AGENDA
RIO DELL PLANNING COMMISSION
REGULAR MEETING - 6:30 P.M.
TUESDAY, MAY 23, 2017
CITY COUNCIL CHAMBERS
675 WILDWOOD AVENUE, RIO DELL

- 1) 2017/0523.01 - Resolution No. PC-109-2017 Approving the Design Review Conditional Use Permit for PMD, Incorporated for the development of three (3) buildings. Building 1: (4) unit retail commercial. Building 2: Warehouse, distribution, and packaging. Building 3: Cannabis Testing Lab (DigiPath), concentrate manufacturing, research and development of cannabis medicinal products, and tissue culturing and plant nursery subject to Conditions of Approval APN 205-111-021 - Case No. DR-CUP 17-02 (**DISCUSSION/POSSIBLE ACTION**) 12

Subject: PMD Inc. Design Review Conditional Use Permit
File No. 205-111-021; Case No. DR-CUP 17-02

SITE PLAN

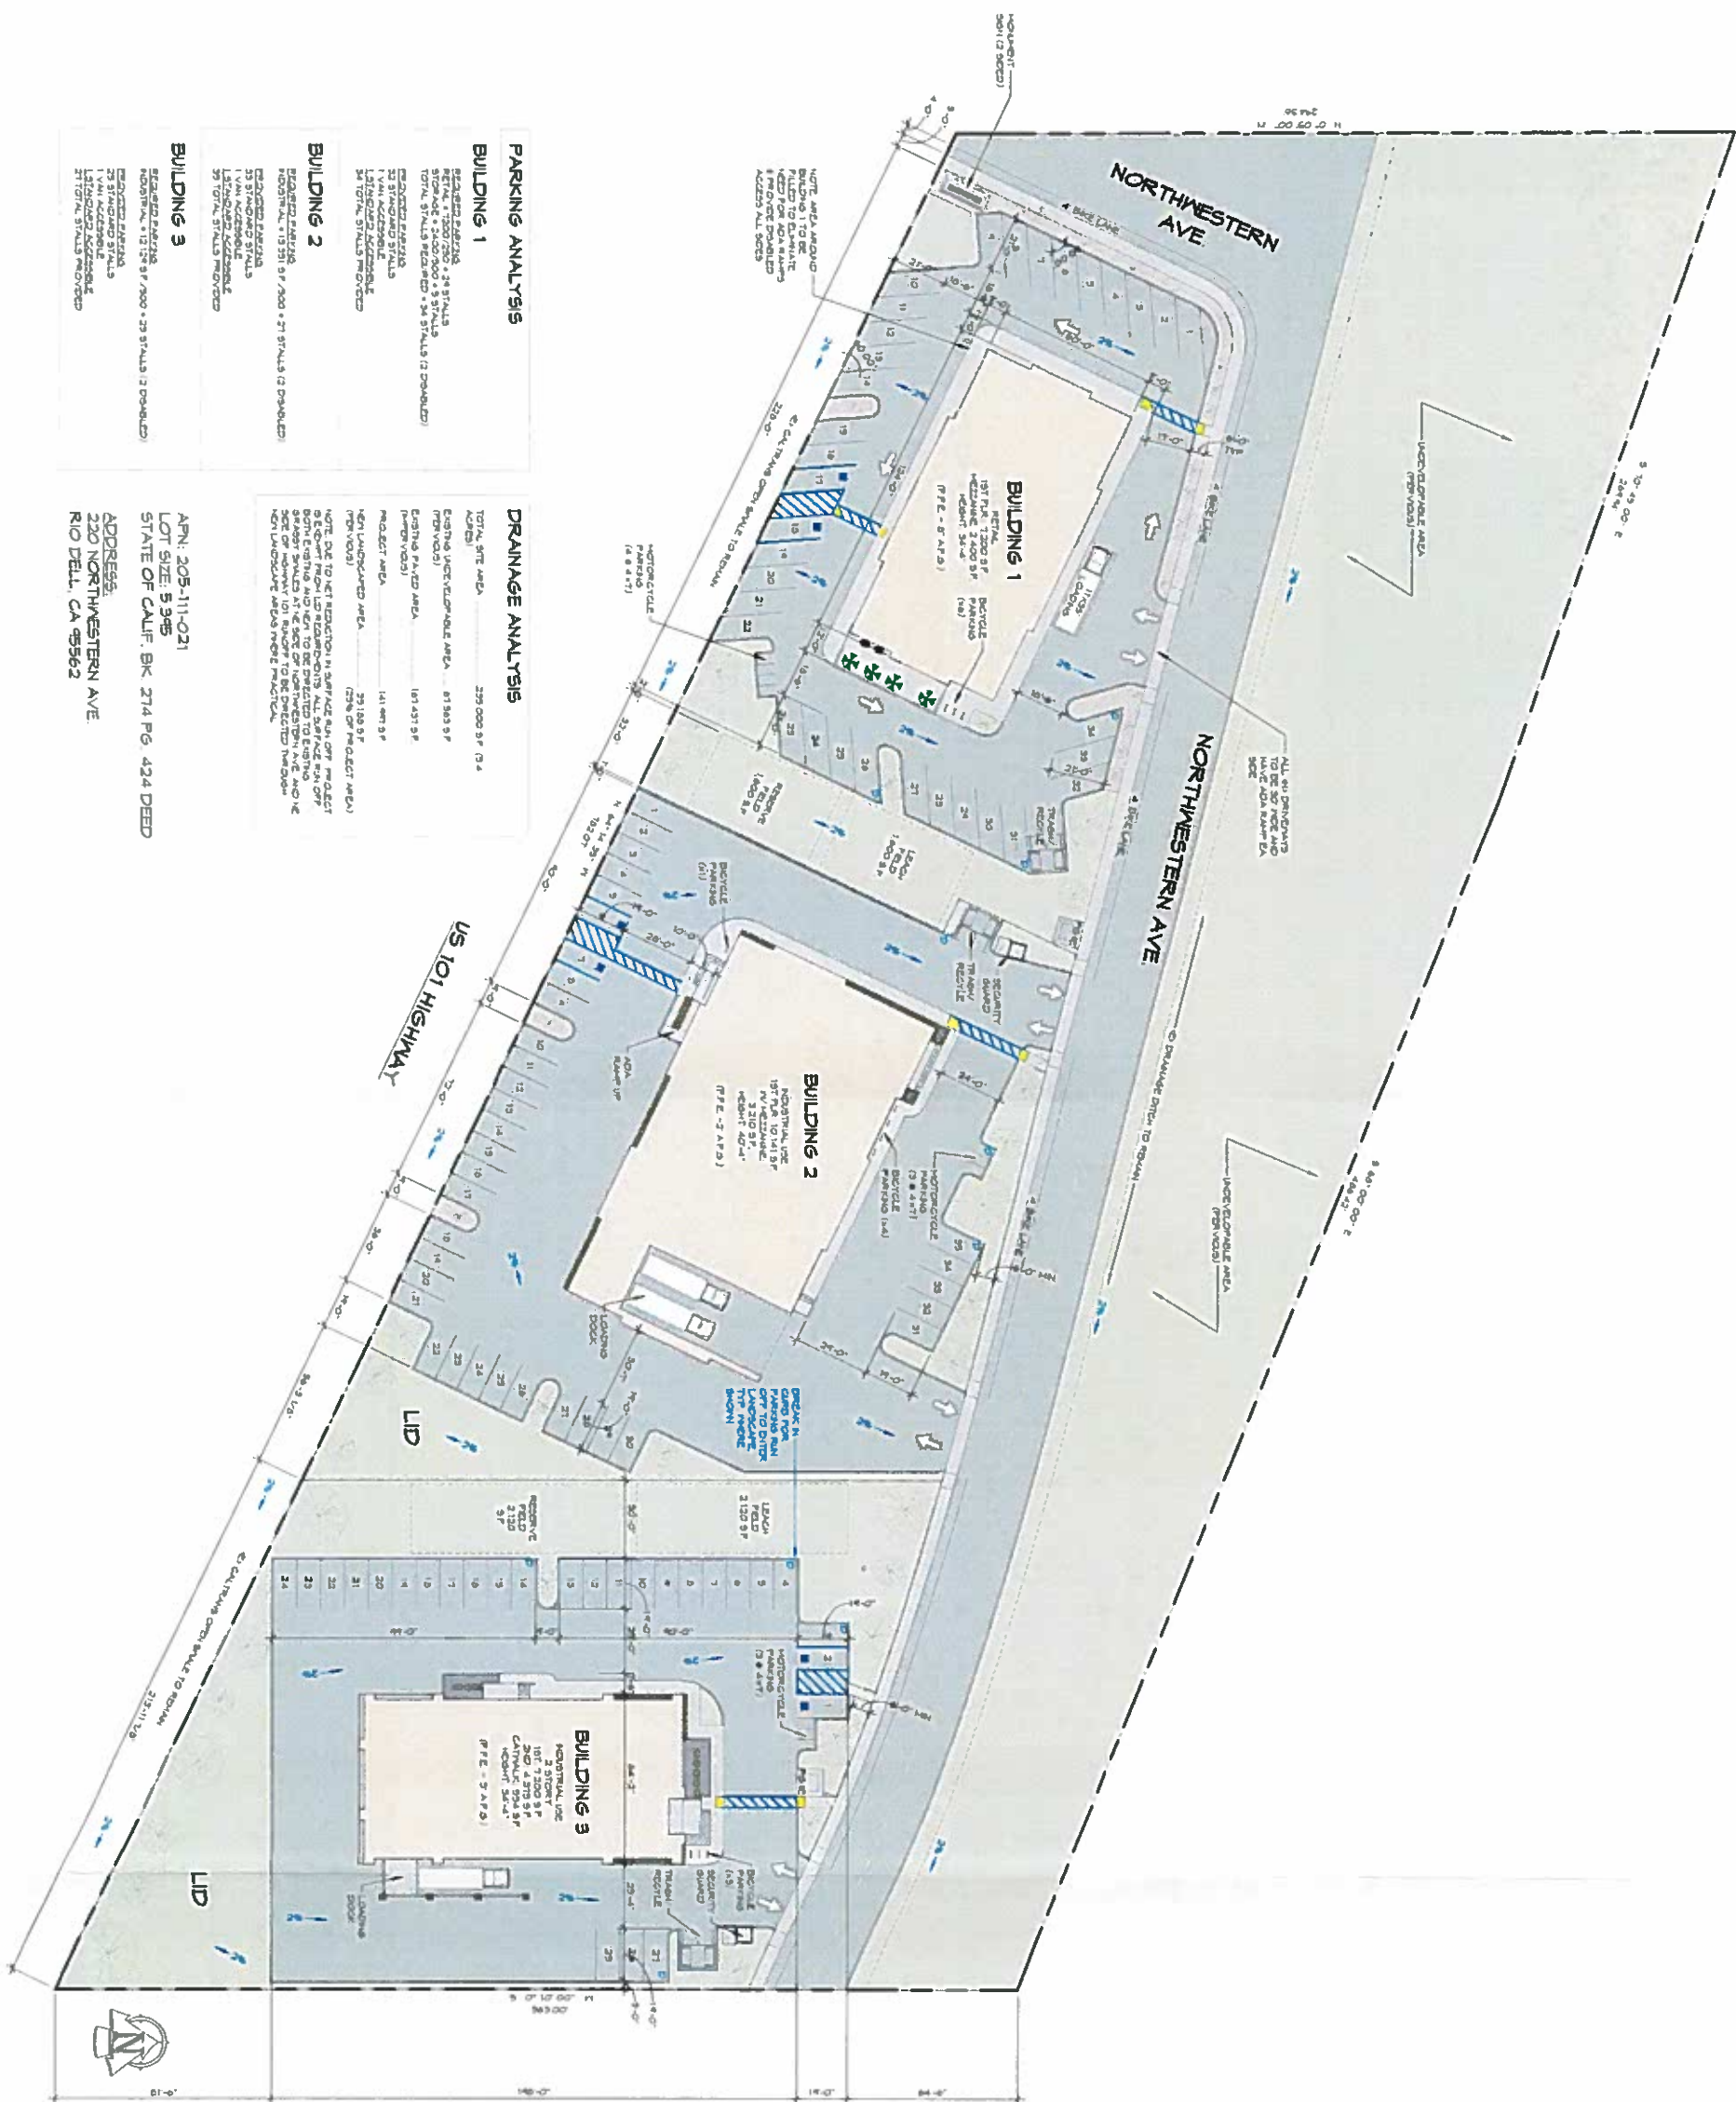
The proposed development includes retail, professional offices and industrial uses spread among the three proposed buildings. The northerly building is required to provide 34 spaces. The site plan identifies 34 spaces, including two disabled spaces, one van space and one standard space. The middle building is required to provide 27 spaces. The site plan identifies 35 spaces, including two disabled spaces, one van space and one standard space. The southern building is required to provide 25 spaces. The site plan identifies 27 spaces, including two disabled spaces, one van space and one standard space. The provided parking exceeds the minimum number of parking spaces.

Section 17.30.180(9) of the RDMC requires concrete curbing at least 6 inches in height and 6 inches wide around the perimeter of the parking and landscaped areas. The required curbing is shown on the site plan. The curbing will have breaks in it to allow stormwater to pass.

Sections 17.30.180(12), (13) and (14) of the RDMC identifies parking area landscape requirements for parking lots containing 3 spaces or more. Landscaping has to be provided throughout the parking lot as a combination of ground cover, shrubs and trees. The landscaping plan does incorporate the use of ground cover including grass, shrubs and trees.

SHEET NAME
**MONUMENT SIGN
PLAN & 3D
RENDERING**

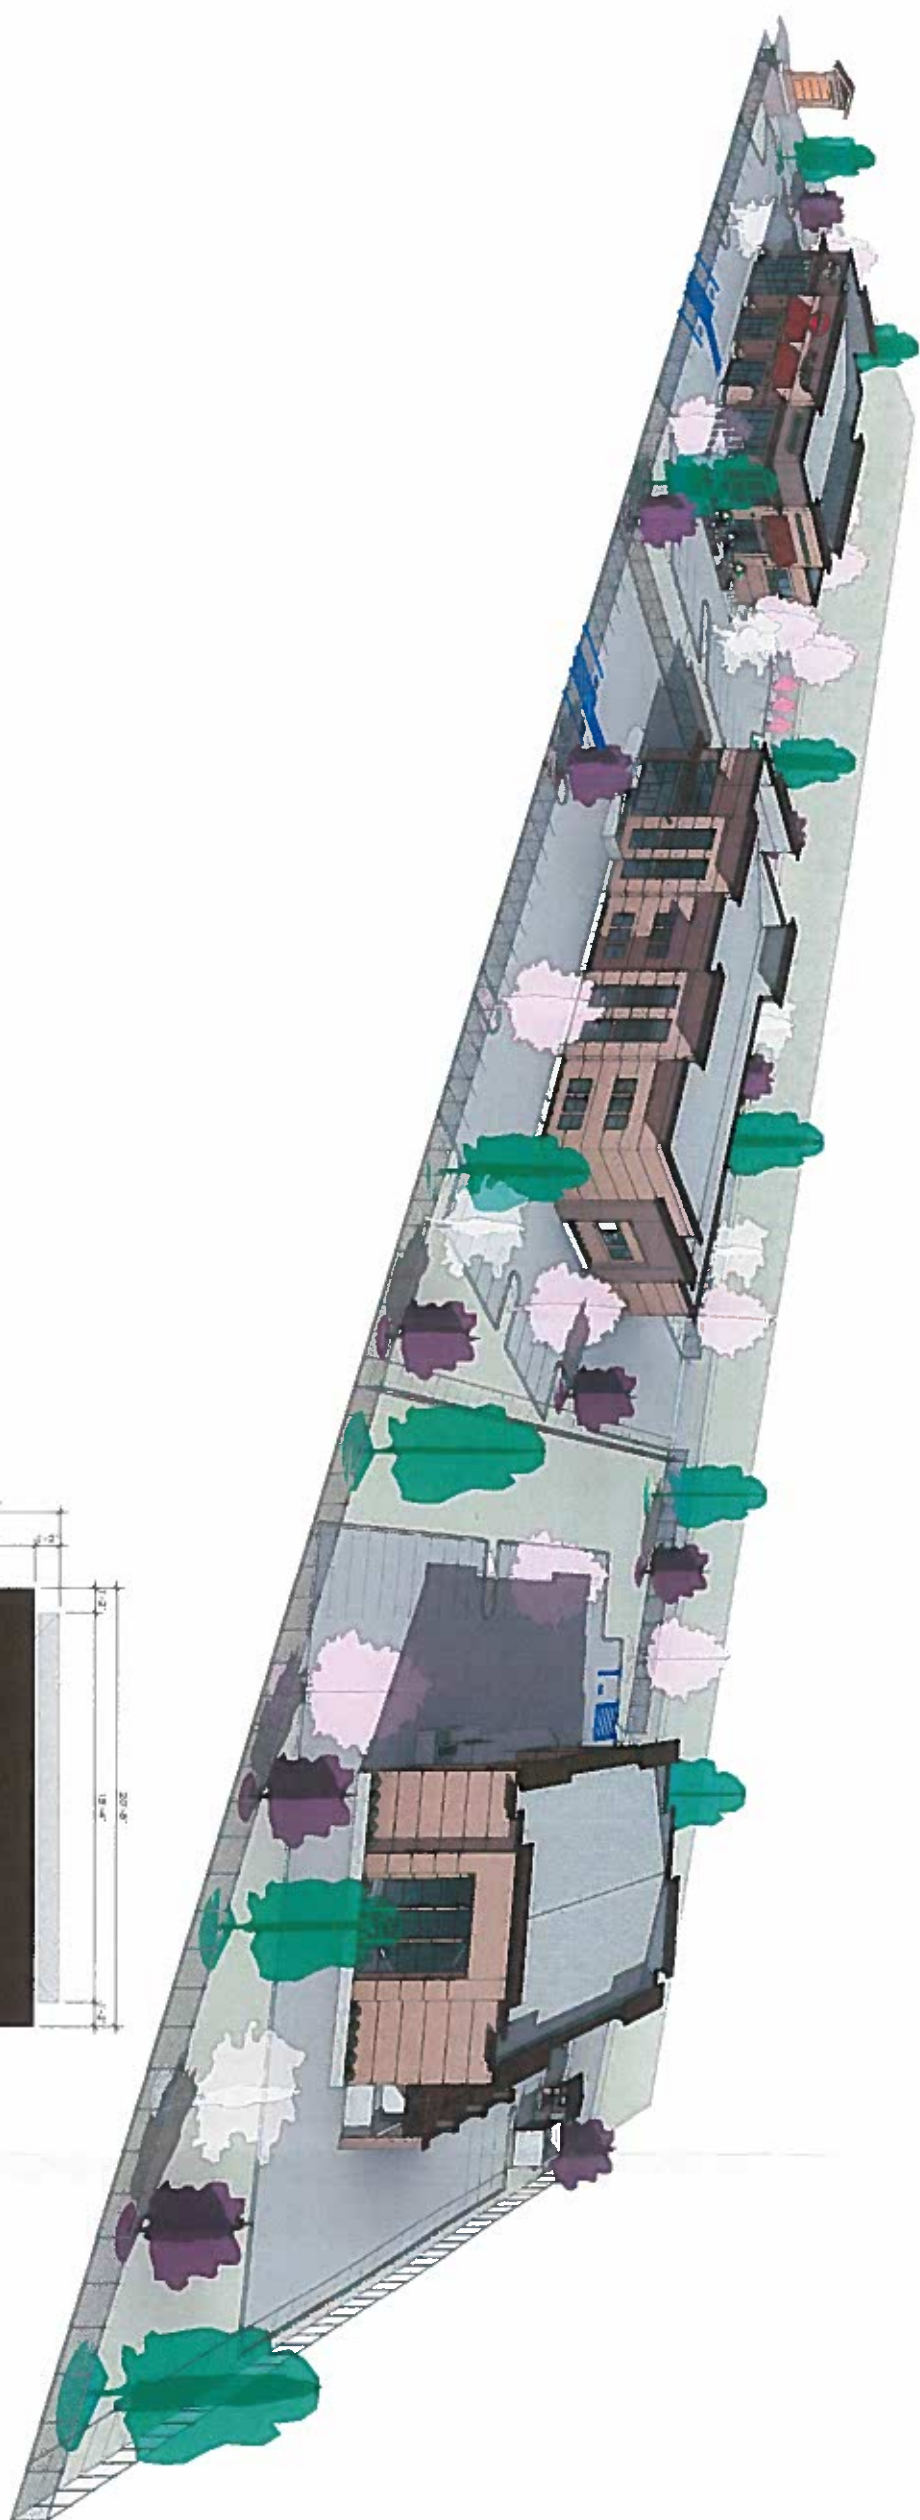
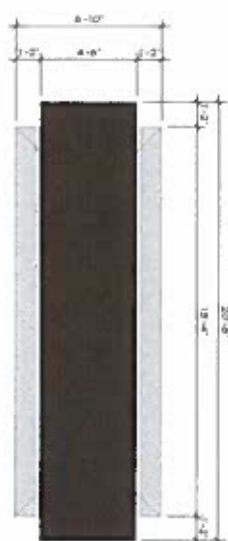
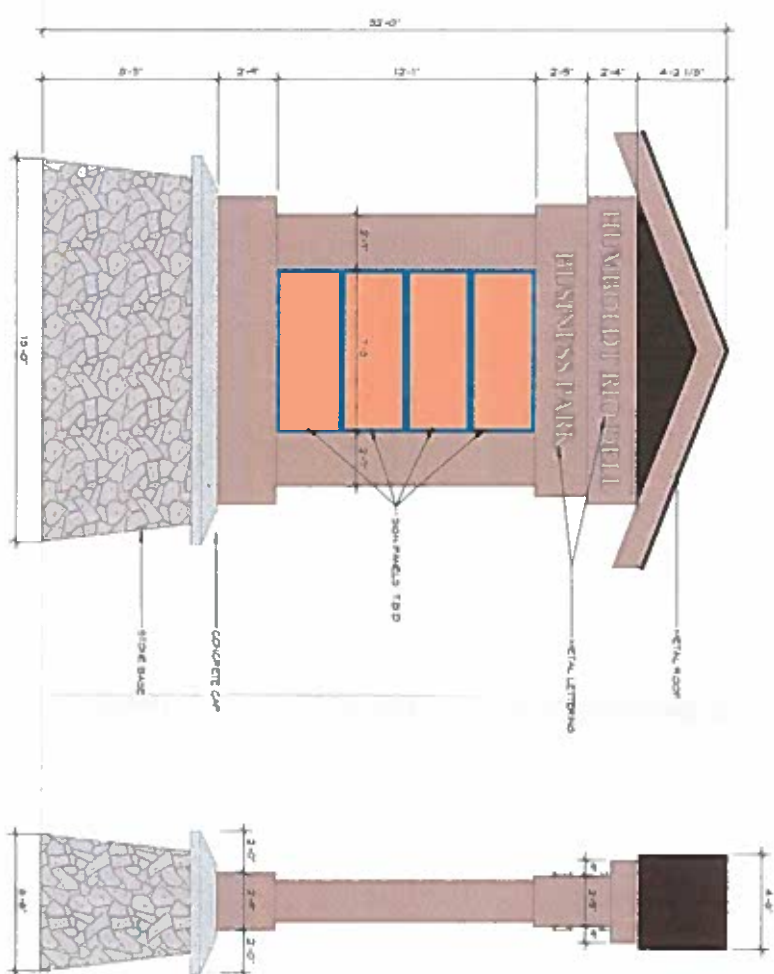
The applicant is proposing a 32 foot tall monument sign at the northwest corner of the parcel. The monument sign will be double-sided with four (4) panels totaling 92 square feet. The sign will be externally illuminated (shielded wall washer directed back at the sign). The "Humboldt Rio Dell Business Park" lettering is 10" high and is on both sides which adds' about another 20 square feet of sign area to each side of monument sign.

2 LANDSCAPE & IRRIGATION PLAN

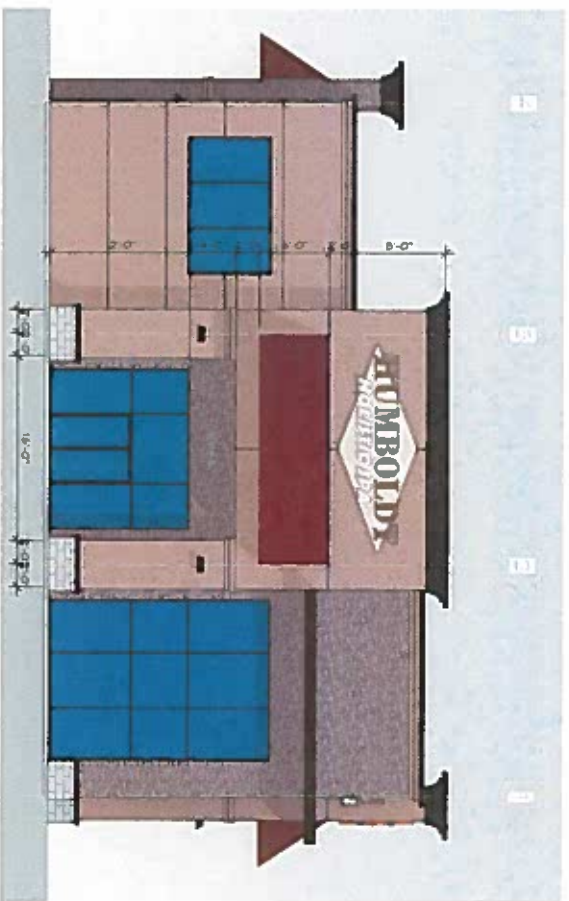
(i) A proposed parking area adjacent to a public street shall be designed with a landscaped planting strip between the street right-of-way and parking area with a minimum depth of 6 feet.

(ii) Landscaping within the planting strip shall be designed and maintained to screen cars from view from the street to a minimum height of 18 inches, but shall not exceed any applicable height limit for landscaping within a setback.

(iv) Trees that reach a mature height of at least 20 feet shall be provided within the planting strip in addition to trees within the parking lot interior required by Subsection (a)(v). Trees types shall have root systems that will not extend beyond the planting area.
